Consultation on Planning Application

Application No. APP/12/00918

Site Address: New Look, 9 West Street, Havant

Proposed Development: Display of 3No. internally illuminated fascia signs and 1No. non-illuminated projecting sign.

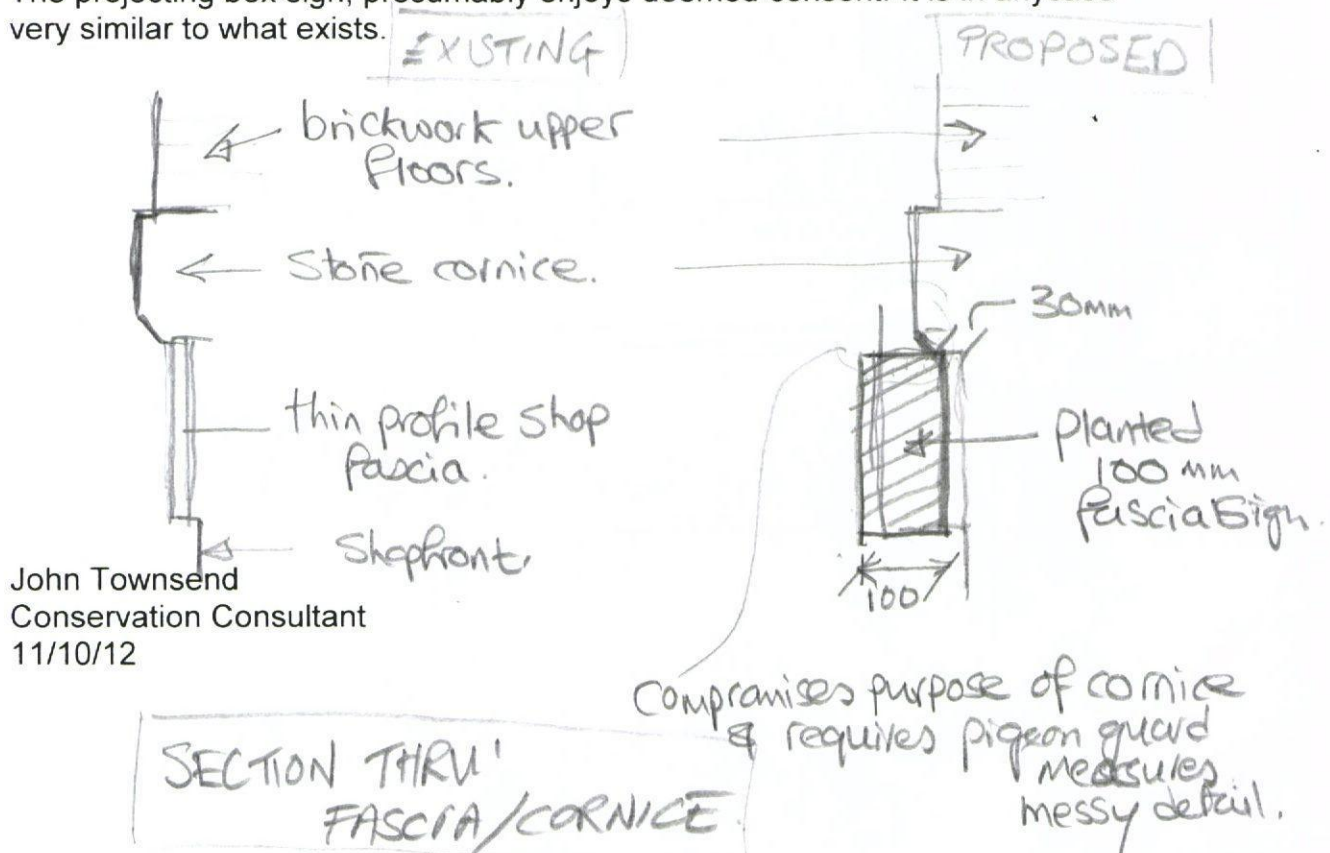
- There are a number of illuminated signs in the vicinity of this property so feel it would be unreasonable to withhold consent on a point of principle.
- Would normally look for lettering only to be illuminated. Here the back panel is illuminated and aluminium lettering applied.
- My concern with what is proposed is that it results in 150mm planted fascia box, which projects forward of the stone cornice and then requires anti pigeon spikes. This is a very messy detail on a well designed modern building.

This looks like a standard format sign. It is common for national companies to also have a "conservation" option up their sleeve. It is appropriate to challenge what is proposed to secure an improved design.

The use of florescent tube illumination is a very old detail and is often surpassed by LED allowing for a much slimmer box and tidier detail. Alternatively a thin back panel with external illumination would be an improvement on what is shown. There should be the opportunity to modify the design to provide a crisper more subtle detail. See sketch below.
